Local Planning Panel

Address: 86-90 Bay Street, Ultimo

Application: D/2026/136

- demolition of 4 storey commercial office building
- construction of 8-9 storey mixed use building
- ground floor retail tenancy
- co-living housing (137 units)
- communal spaces (ground & Level 6)

apartment layout alternative 2

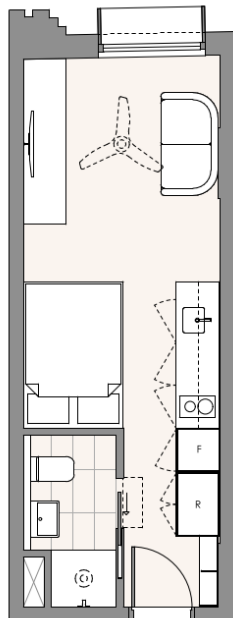
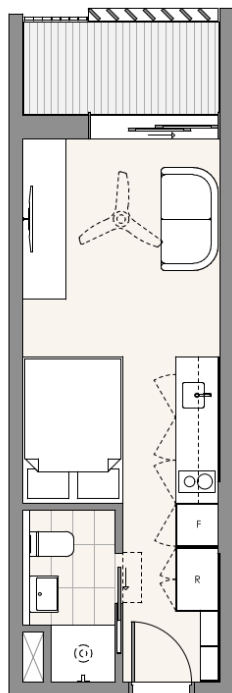
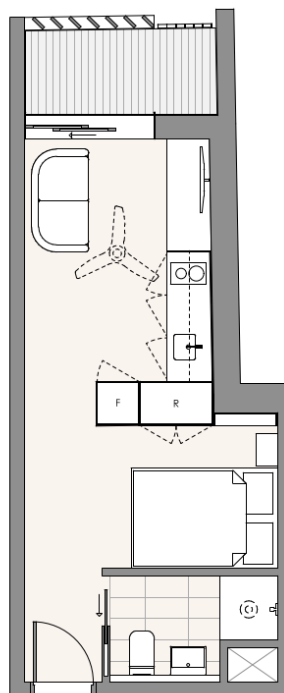
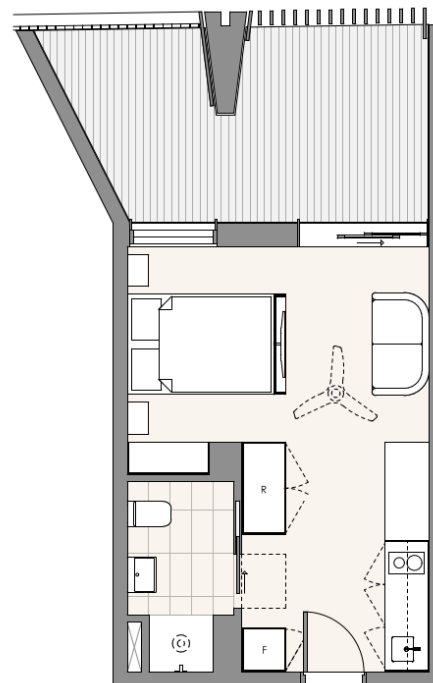
control	proposed	consistency with control
room widths	3.5m	2.7m	no
bike parking	conveniently located	far from entry, 3 sets of doors	no

- low residential amenity: low ceiling heights, insufficient room widths & separation distances
- dark communal spaces, deep courtyard with insufficient landscaped spaces, reliance on roof terrace area for 137 rooms
- all ventilation to courtyard (kitchens & air-con) provides noisy and heated space
- non-provision of tanks for irrigation
- bike & laundry locations not appropriate

Design Advisory Panel Residential Subcommittee

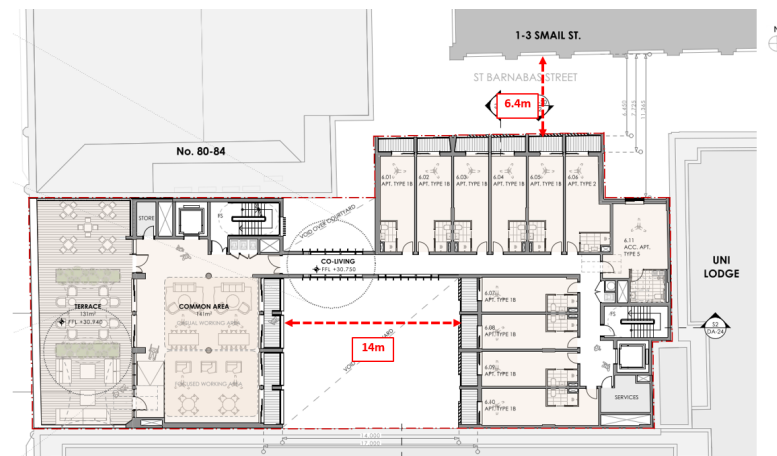
- height & FSR breaches: overdevelopment & poor residential amenity
- DA should comply with SEPP building separation, privacy screens not appropriate
- floor-to-floor heights should be increased (commercial & residential)
- courtyard & roof terrace sizes should be increased for better amenity
- room widths should be increased to DCP minimum
- laundry should in better location
